Addendum No.: 4

Date of Addendum: June 17, 2020

Willard Diloreto Parking Garage
Paul Manafort Sr. Drive
New Britain, CT
CF – RC – 402

ARCHITECTURAL STAINLESS STEEL MESH PANEL
OPEN AREA: 75%, WEIGHT: 1.27 LBS./ SQ. FT.

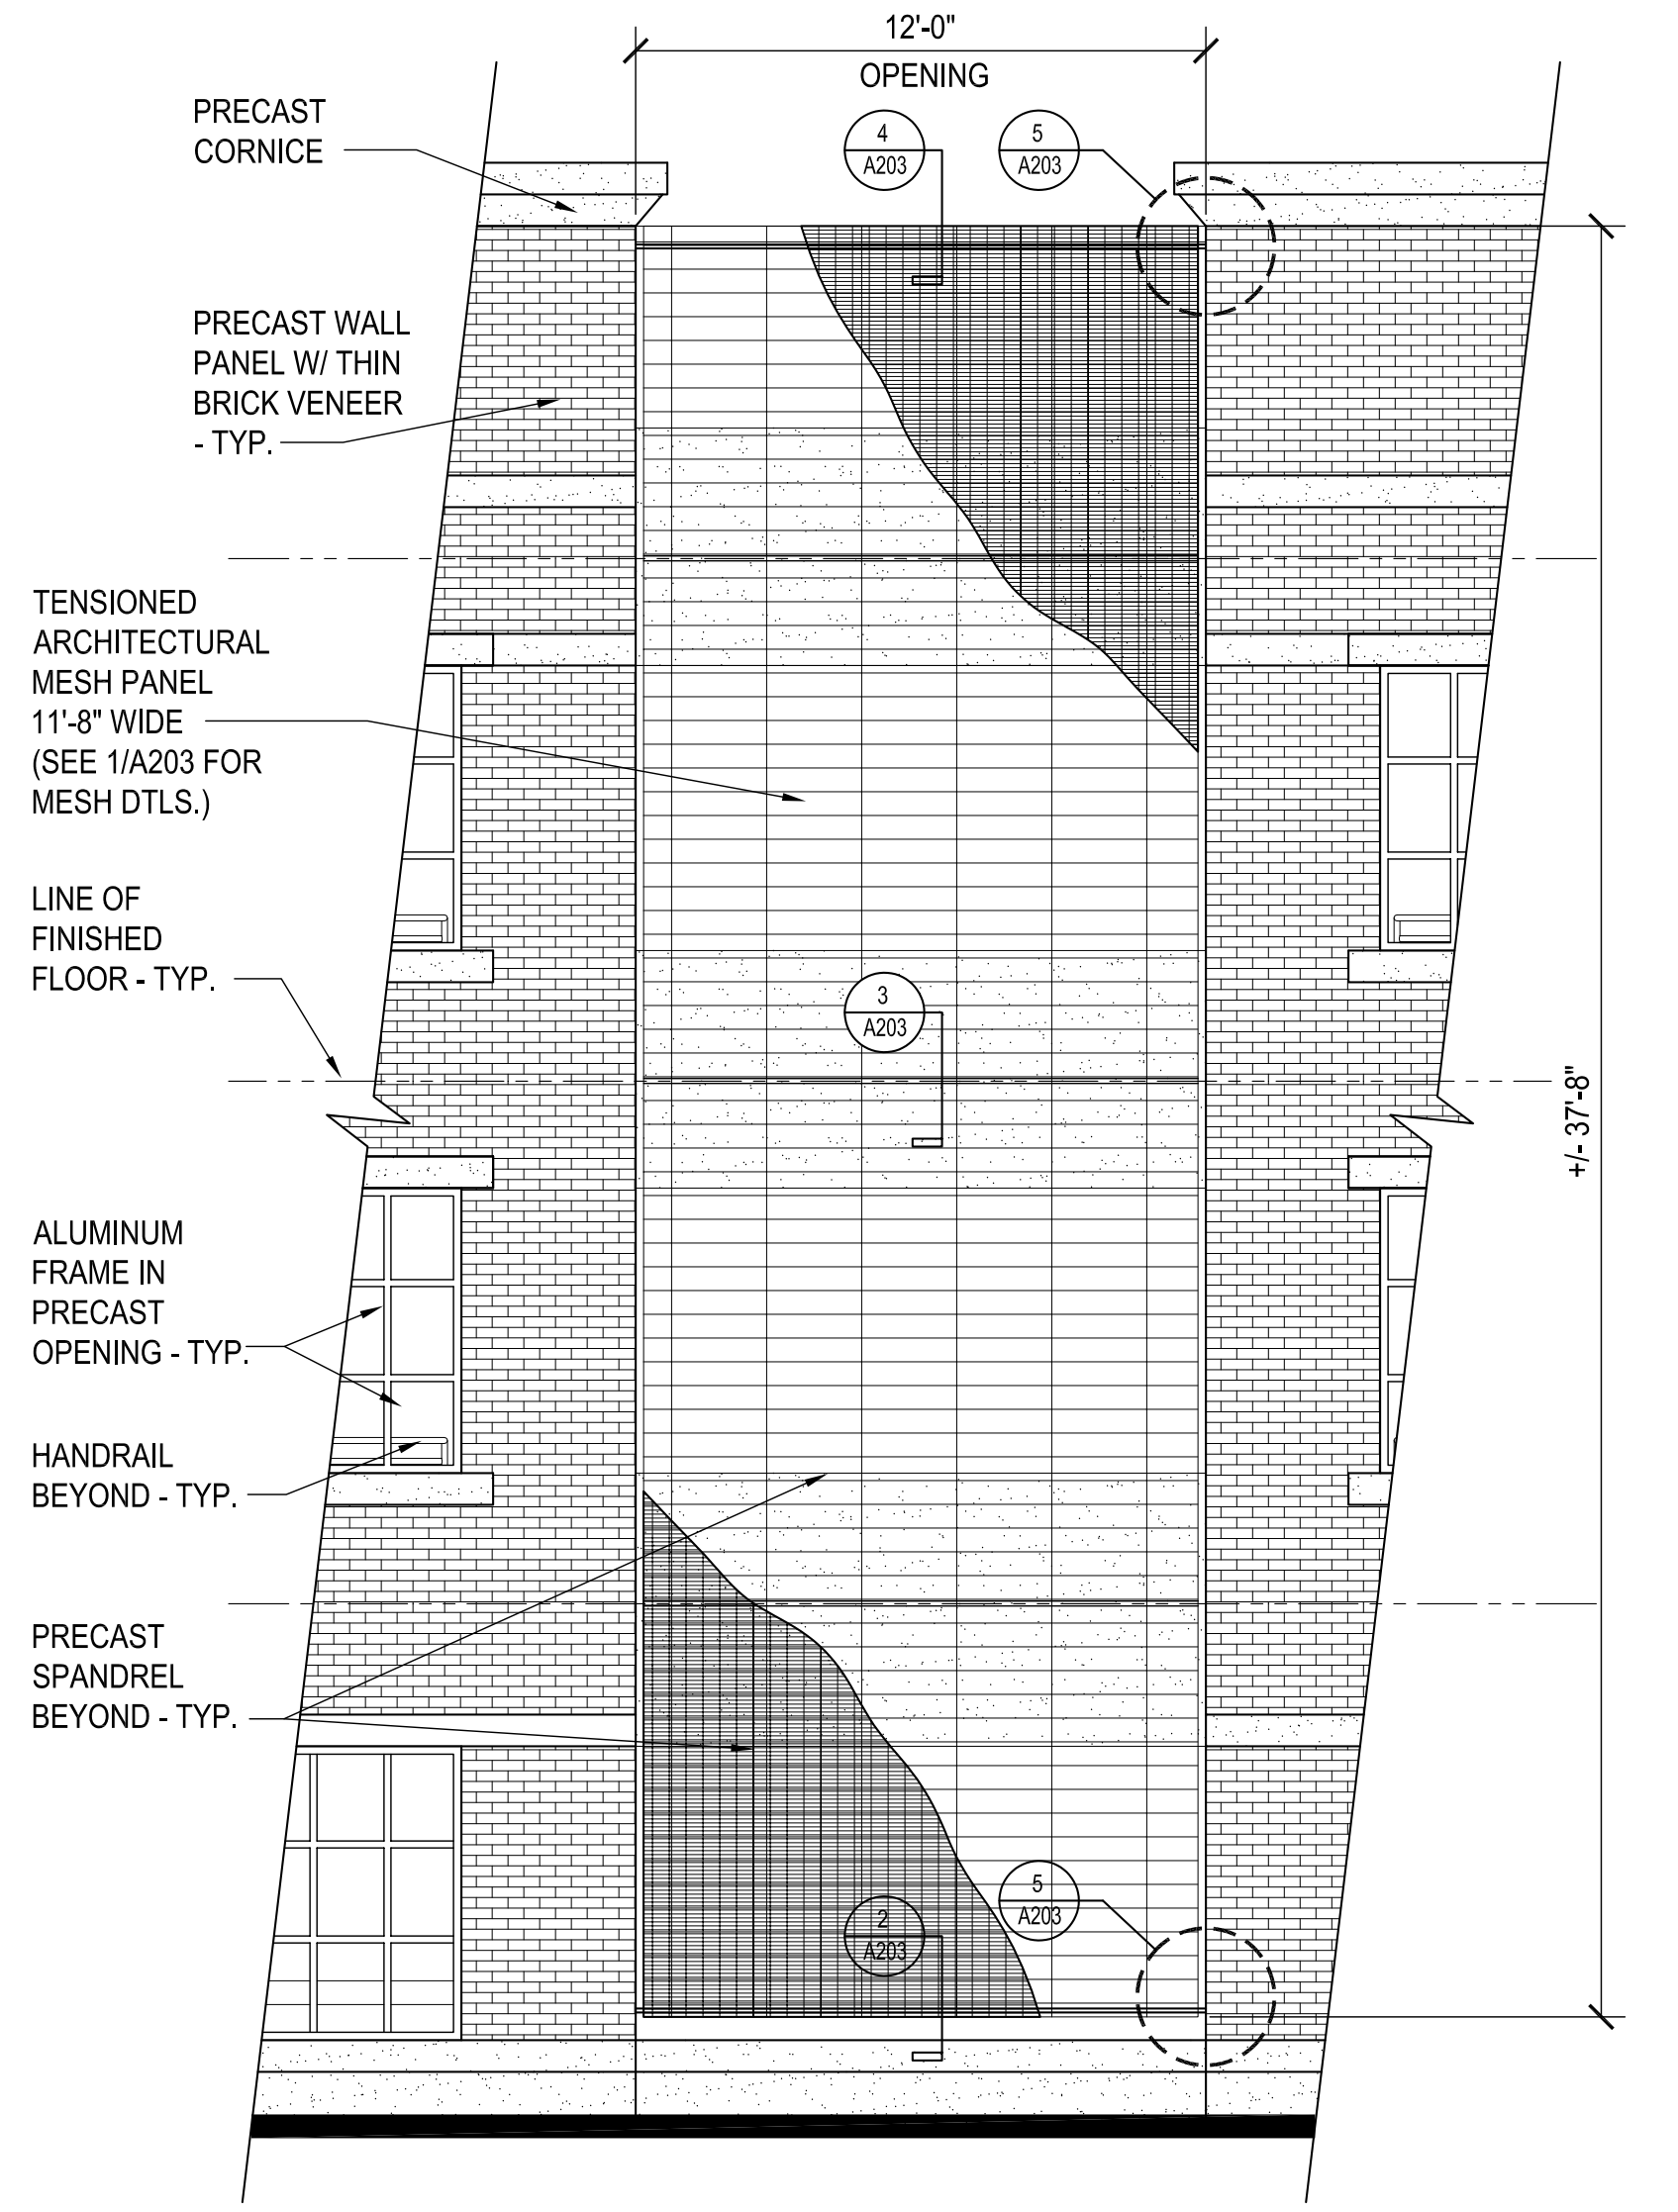
Question: Drawing A203 is calling for Galvanized continuous bars and attachments at the mesh screens. Due to the tendency to wear and rust over time, would Stainless 316L be recommended in lieu of Galvanized? See attached.

Answer: See revised drawing A203. Details have been revised to include all stainless steel hardware for the mesh screen.
